**PROPOSED TECHNICAL SPECIFICATION CHANGES
TORUS VENT SUBMERGENCE LEVELS AND INSPECTION INTERVALS**

(JPTS-90-014)

JAMES A. FITZPATRICK NUCLEAR POWER PLANT

Docket No. 50-333

Figure 1

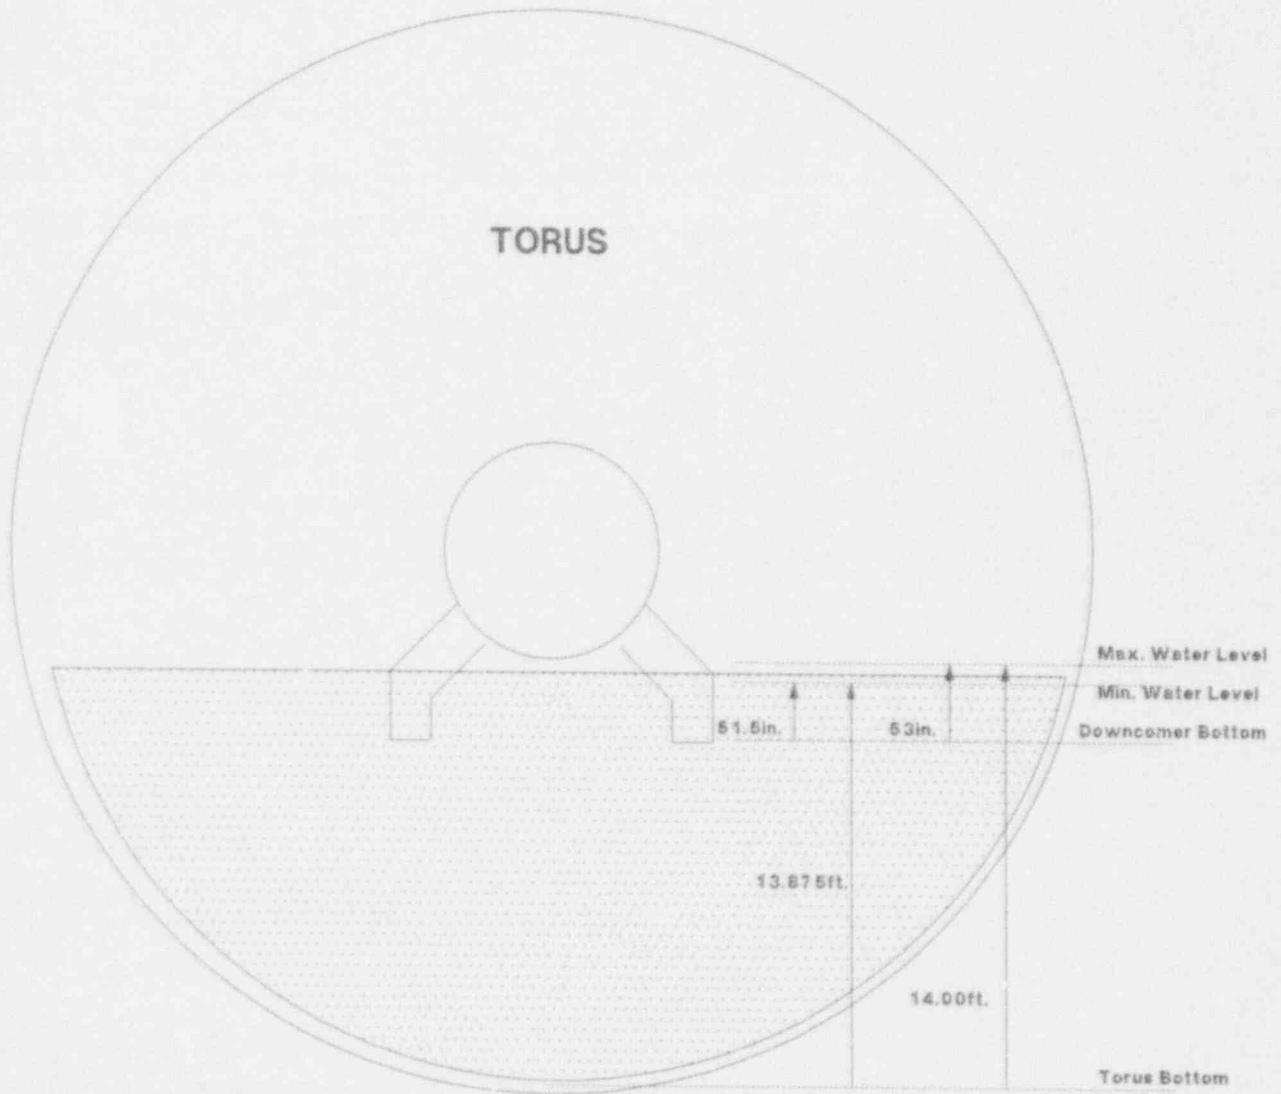
The proposed changes revise the reference point used in Specification 3.7.A.1 for determining the water level in the torus. The current specification provides limits on the maximum and minimum torus water levels by referring to the submergence level of the downcomer vents. Downcomer submergence was used in FitzPatrick plant specific calculations to establish the torus water level requirements (References 1, 2, and 3). The proposed change to the LCO measures water level relative to the bottom of the torus. Referring to the maximum and minimum water levels above the bottom of the torus makes the LCO consistent with the instrumentation used to monitor water level. The changes also revise the units of measurement to "feet" for consistency with control room instruments. Figure 1 illustrates the water level measurement.

NOTE: Not To Scale
Max. to Min. Waterlevel = 0.125 ft. = 1.5 in.
